Subject: S.P. 2774-27504A  
Bridge No. 27504  
Revised Plan Sheets

Subject: S.P. 2774-16  
Bridge No. 27504  
Revised Plan Sheets

## Addendum 1 for changes to the Plans and Special Provisions for Bridge Nos. 7268 and 27504:

SHEET NO. 1-R2 OF 34 SHEETS

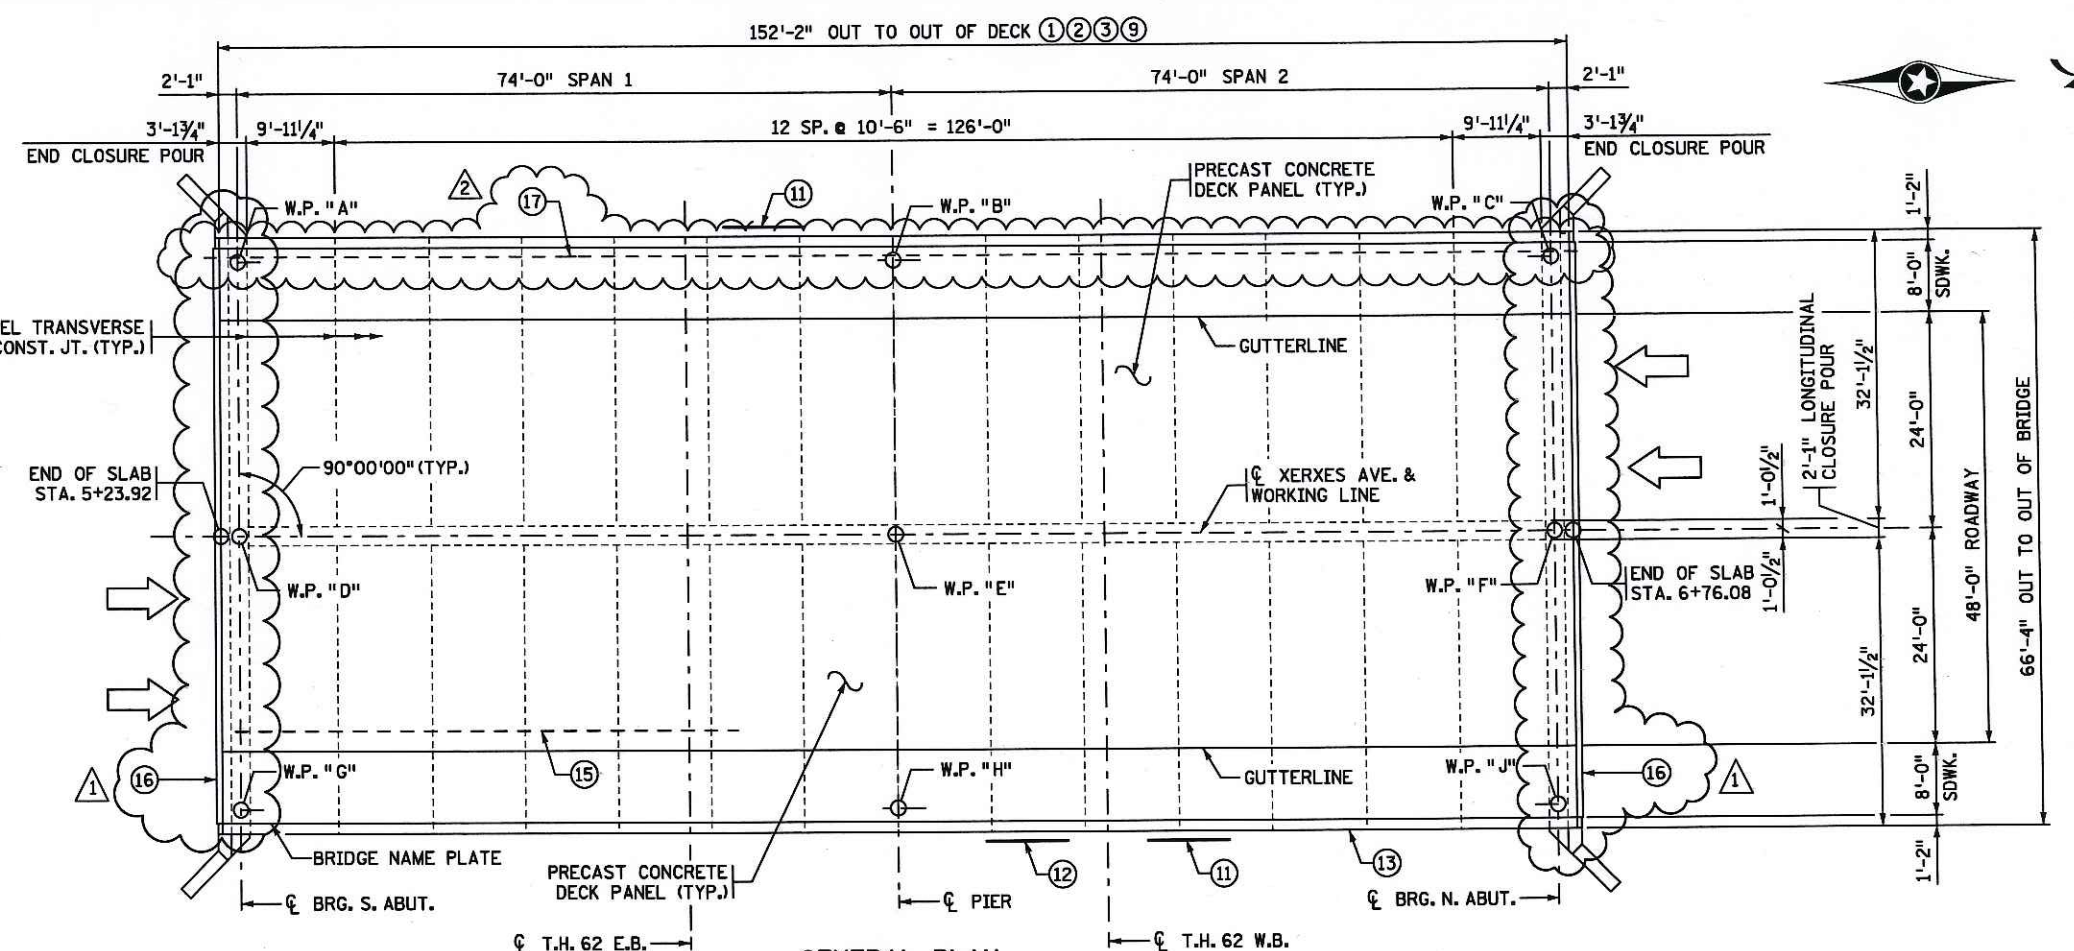
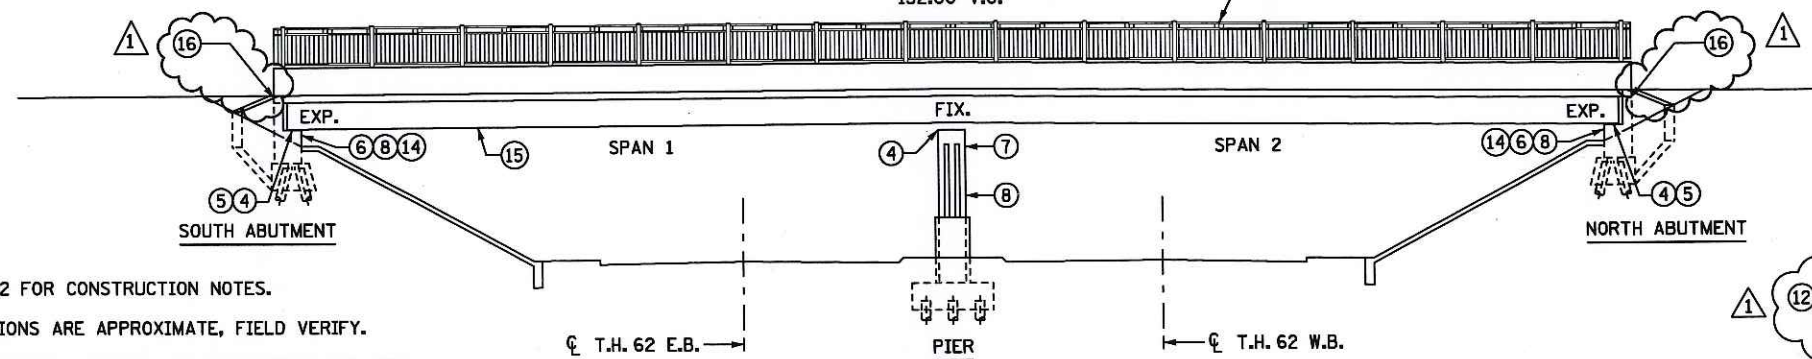
Enclosed are the revised plan sheets 1-R2, 2-R2, 3-R2 and 23-R1 for Bridge 27504. These revisions were made to add conduit through the sidewalk on the bridge. Since this adds a pay item, this revision will affect the cost for this project.

- 8) On Sheet 1R of 34 for Bridge No. 27504 the following changes were made:
  - a. Notes and call-outs were added for reconstruction of paving brackets.

- b. Circle note 12 was revised
  - c. Signatures were updated.
- 9) On Sheet 2R of 34 for Bridge No. 27504 the following changes were made:
  - a. In the “Schedule of Quantities”, the quantity for Structural Steel (3309) changed from 2000 pounds to 3400 pounds; and the quantity for Anchorages Type Reinf Bars changed from 96 each to 184 each.

DES: RJR DR: BEP APPROVED: 7/30/13  
 CHK: GBB CHK: TRS/BJJ  
 SHEET NO. 3-R2 OF 34 SHEETS

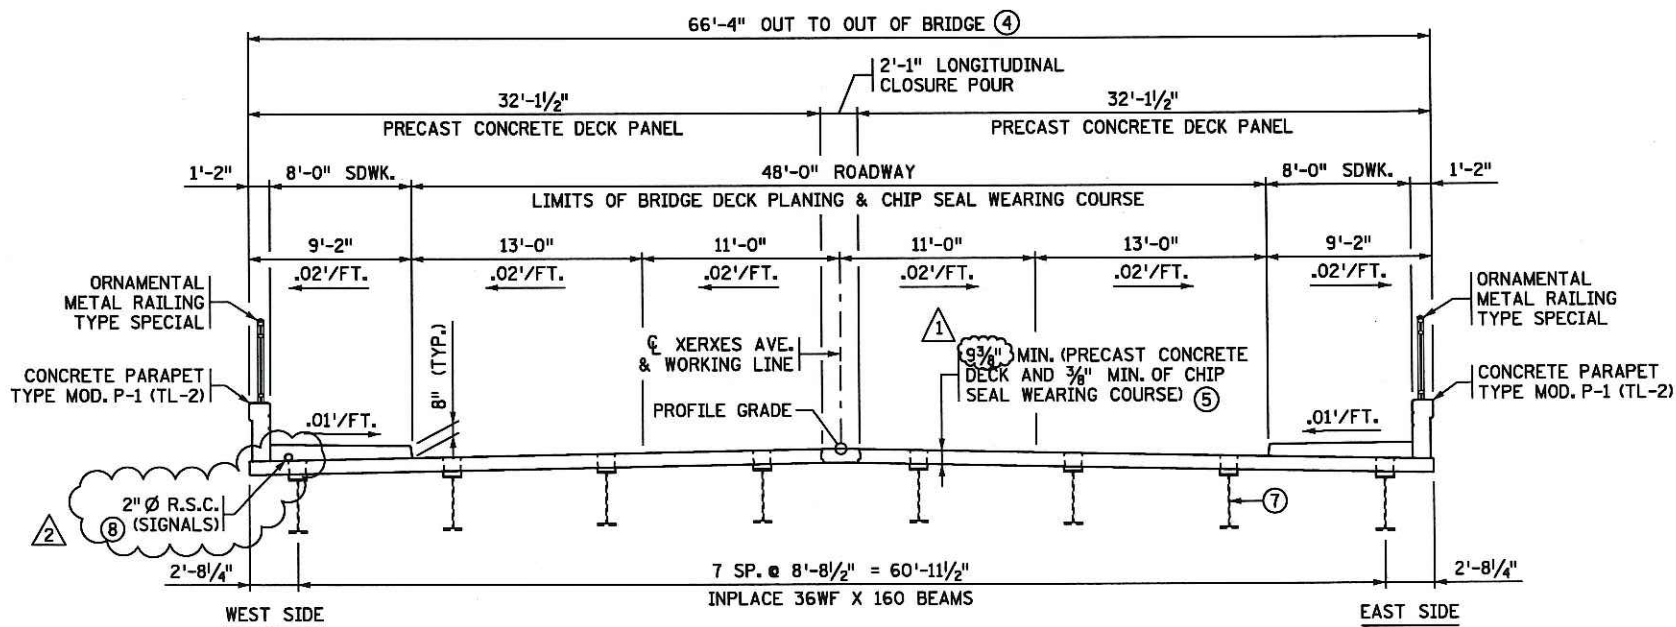
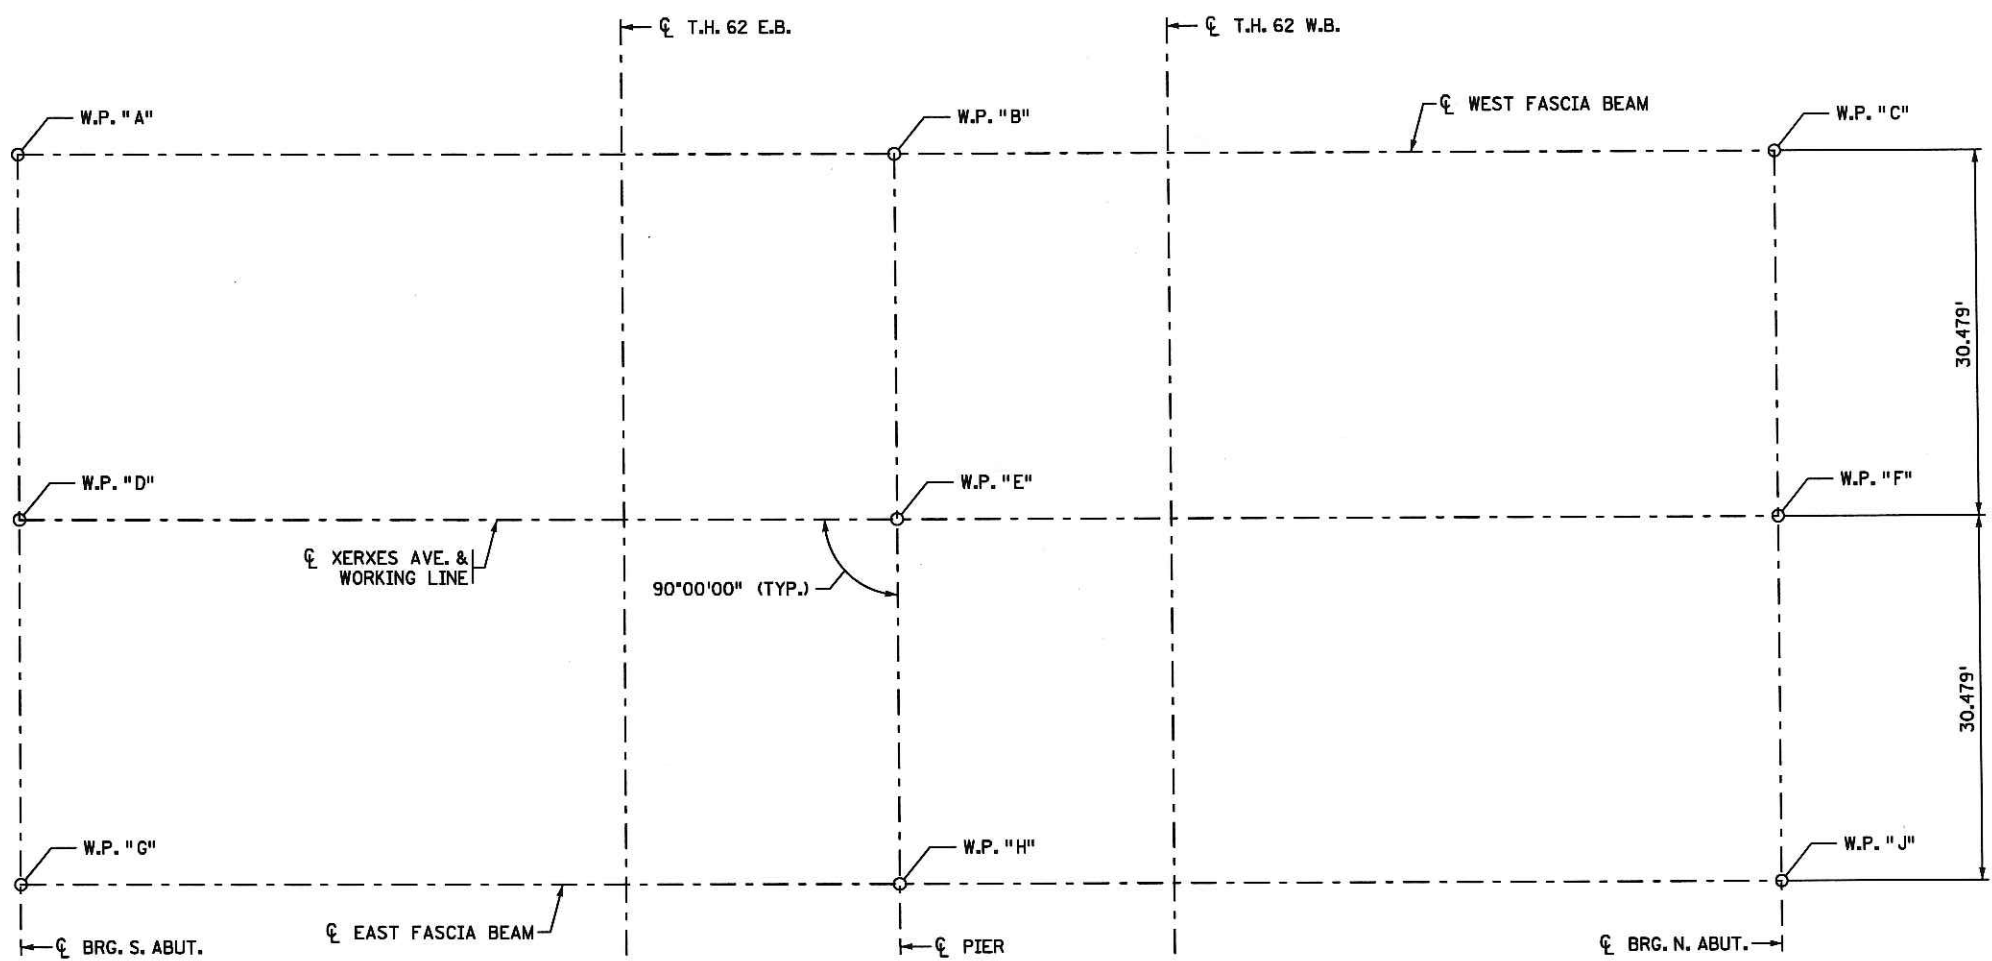
- a. Deck thickness was revised in “Reconstructed Transverse Section”.
- 11) On Sheet 5R of 34 for Bridge No. 27504 the following changes were made:
  - a. Circle note 3 was revised.

DES: DR: BEP APPROVED: 5/29/13  
CHK: CHK: TRS  
SHEET NO. 6R OF 34 SHEETS

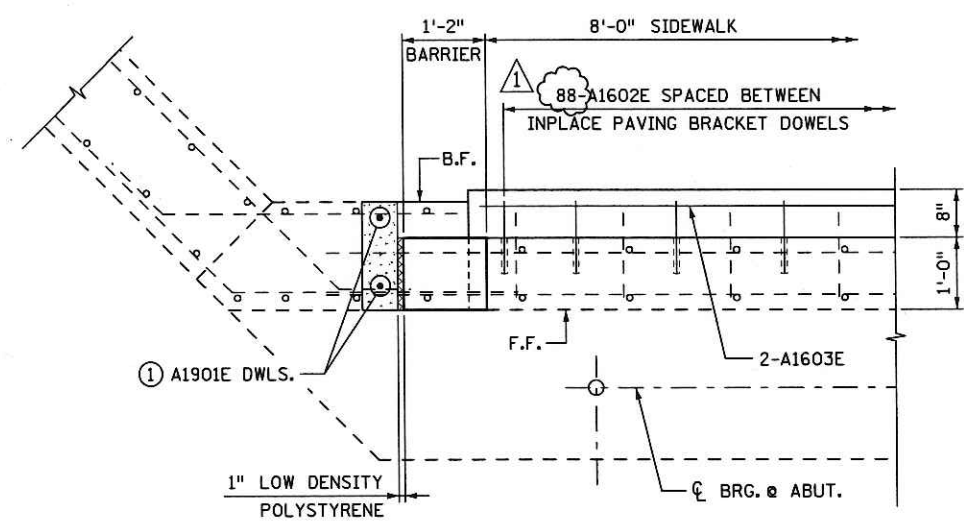
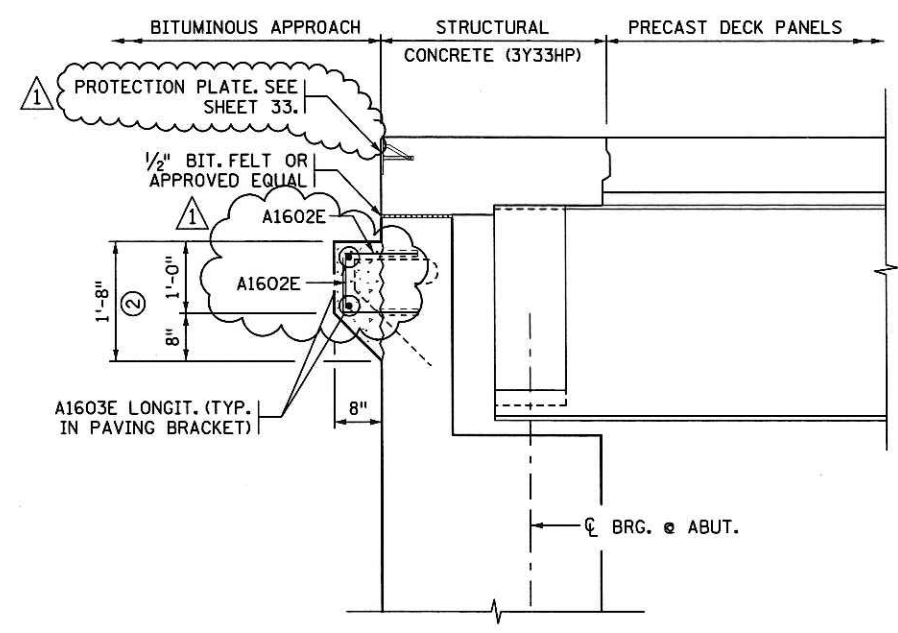
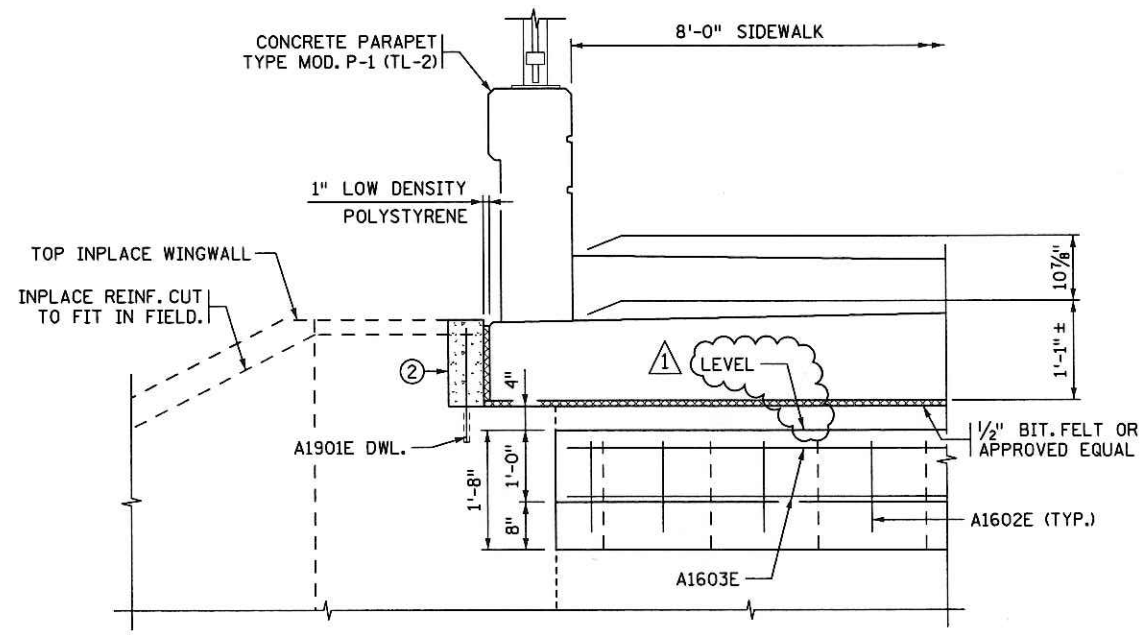
- 12) On Sheet 6R of 34 for Bridge No. 27504 the following changes were made:
  - a. A second reinforcing anchorage was added to the paving bracket, with quantities adjusted accordingly.

- b. A note was added specifying the paving bracket is level.
  - c. A call-out for the deck protection plate was added

DES: RJR DR: BEP APPROVED: 5/29/13  
 CHK: GBB CHK: TRS  
 SHEET NO. 8R OF 34 SHEETS

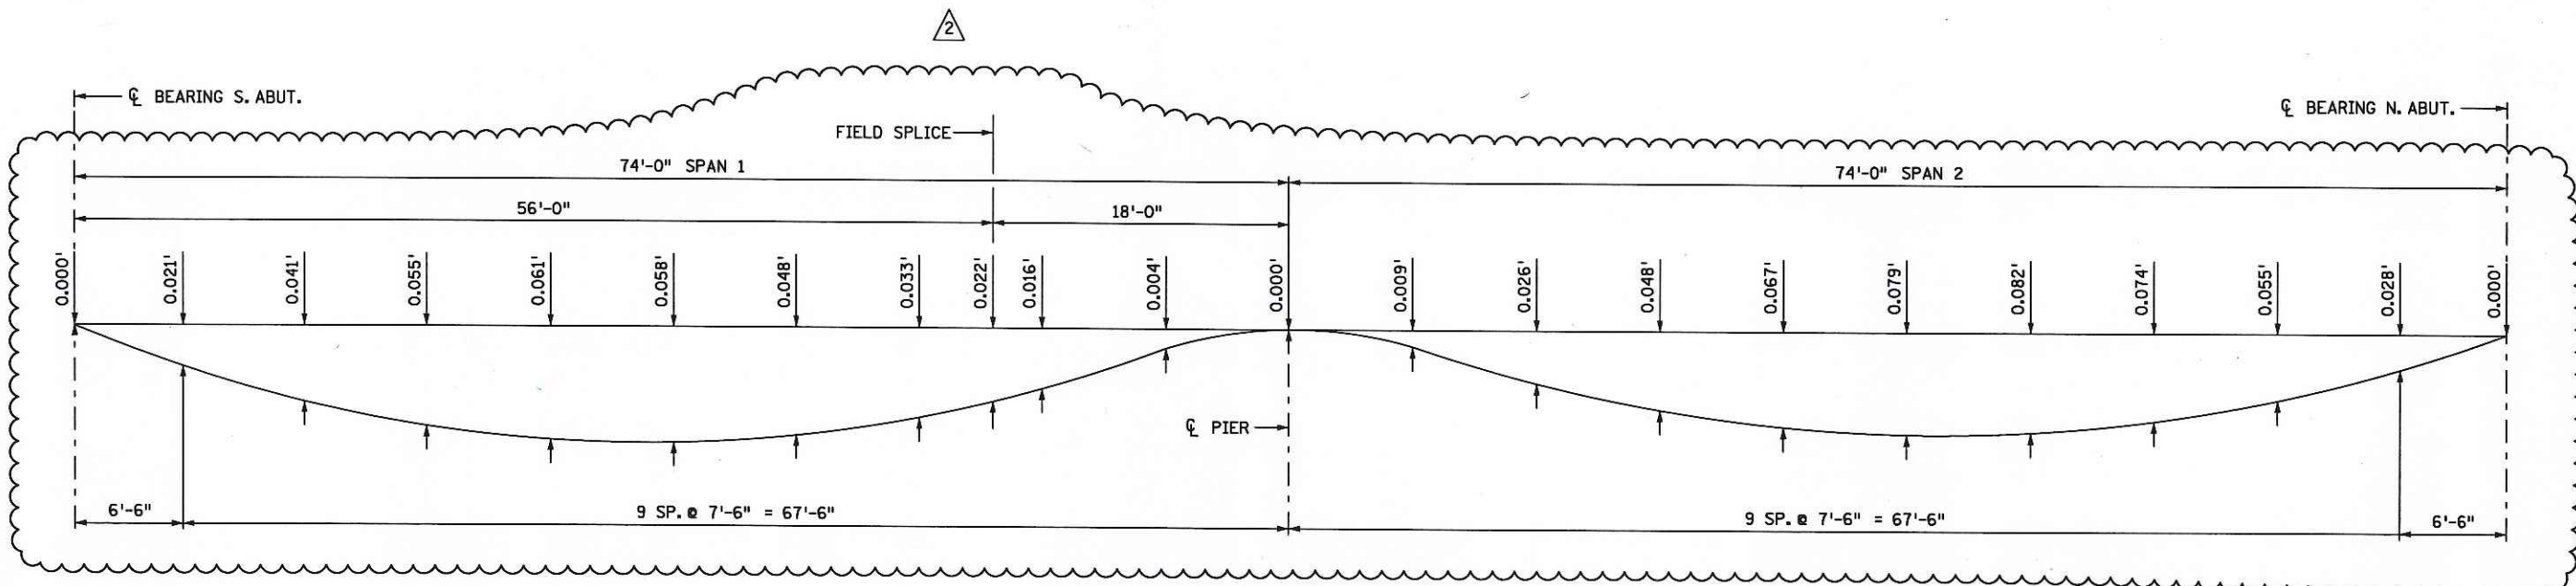
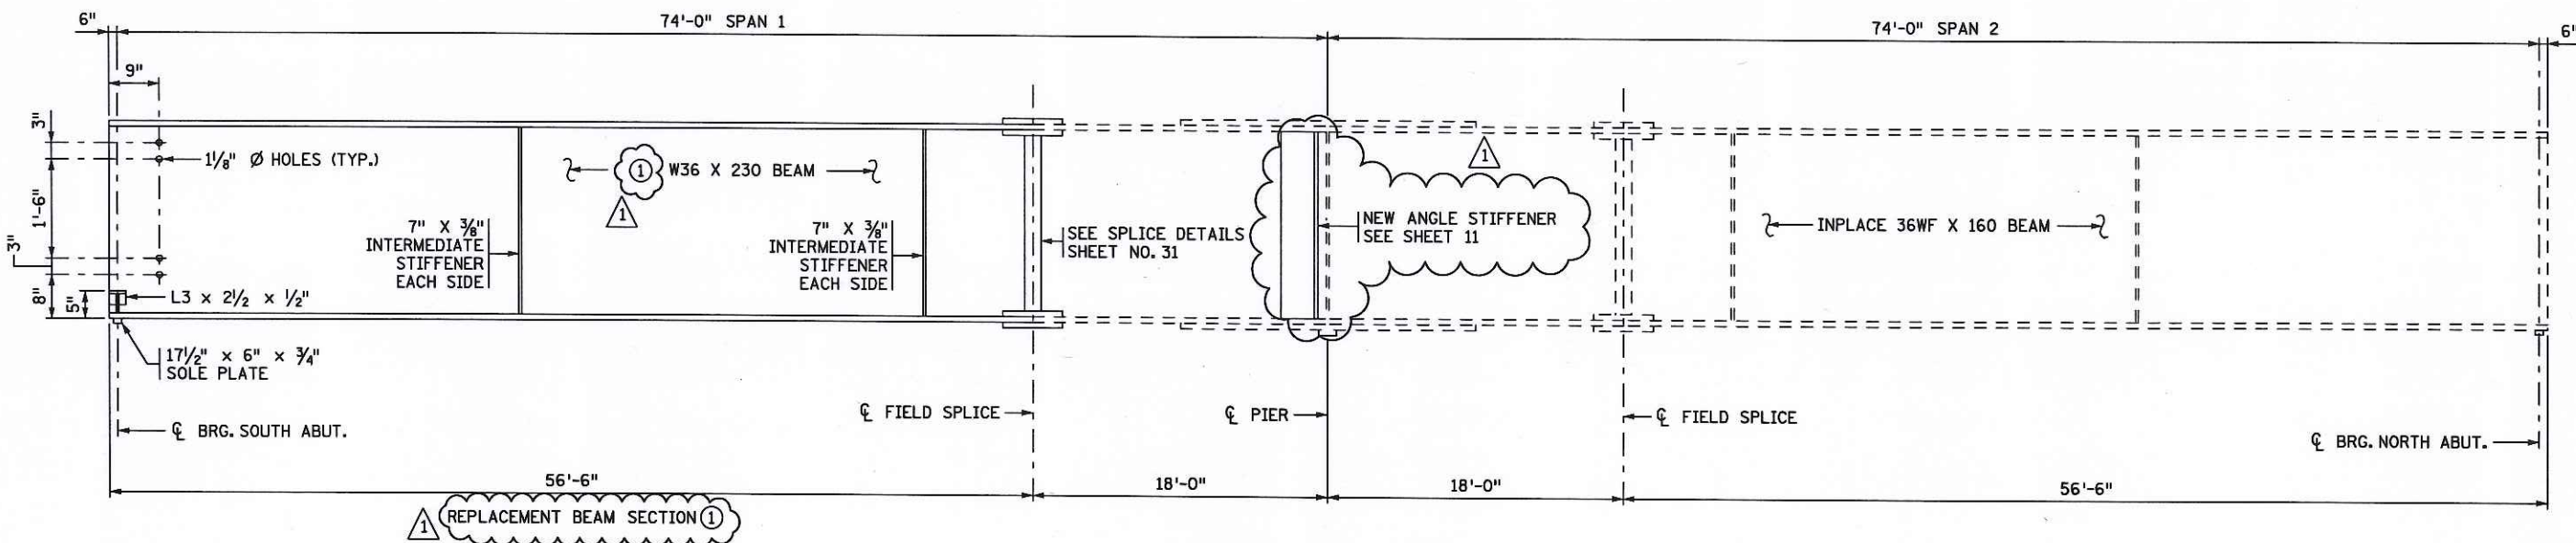
13) On Sheet 8R of 34 for Bridge No. 27504 the following changes were made:

- a. Revised notes to clarify new steel and salvaged steel.
- b. Added stiffener angles and call-outs to "Framing Plan".
- c. Added circle note S1 for stiffener angles.
